**TOWNSHIP OF NORTH BRUNSWICK**  
710 HERMANN ROAD  
NORTH BRUNSWICK, NJ 08902  
Tel.: (732) 247-0922 x440

**MEMORANDUM**

**SUBJECT:** Block: 244 Lot: 2  
Street Address: 1140 South Boyd Parkway  
North Brunswick, NJ 08902  
Applicant: Mr. Nestor Rosero and Wendy Polanco

- o 11 – sheet Township of North Brunswick (Variance Application Form C)
- o 3-sheet plans entitled, Interior Renovation and Addition for Rosero Residence dated 9/30/2022, revised 11/16/2023, prepared by Daniel Fortunato, Architect. P.A.

SITE SURVEY  
 1" = 30'-0"

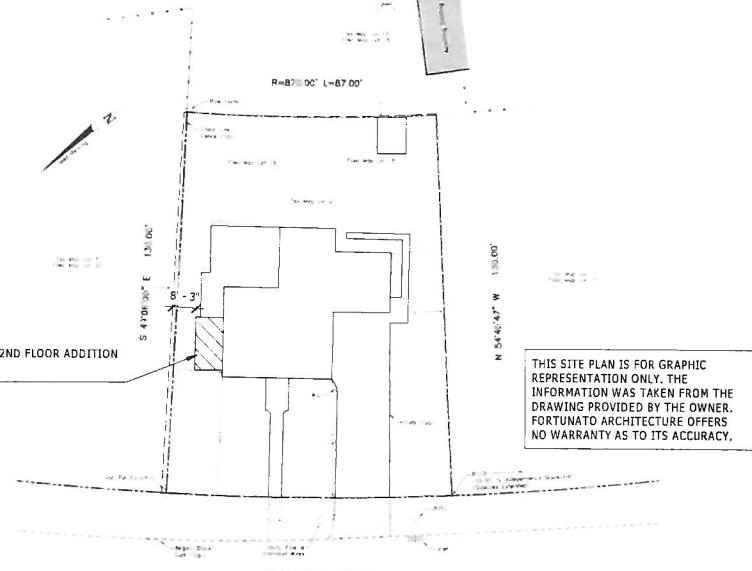
1. The applicant proposes to legitimize an existing second floor addition that was constructed without required zoning approval and construction permits. The 170 SF addition is above the existing sunroom which was also constructed without permits. The sunroom and

second story addition encroach into the side yard setback; therefore, a variance is required. The Township has issued both Zoning and Construction Violations.

- 3. The variances associated with the existing sunroom and second story addition are summarized as follows:

<u>Description</u>	<u>Minimum Required</u>	<u>Existing</u>
Minimum one (1) Side Yard	Twelve (12) Feet	8.25 feet *
Both Side Yards	Twenty-Eight (28) Feet	27.35 feet *

\*Variances Required

Applicant should justify the setback variances and provide testimony to satisfy the C-1 (hardship) and/or C-2 variance criteria.
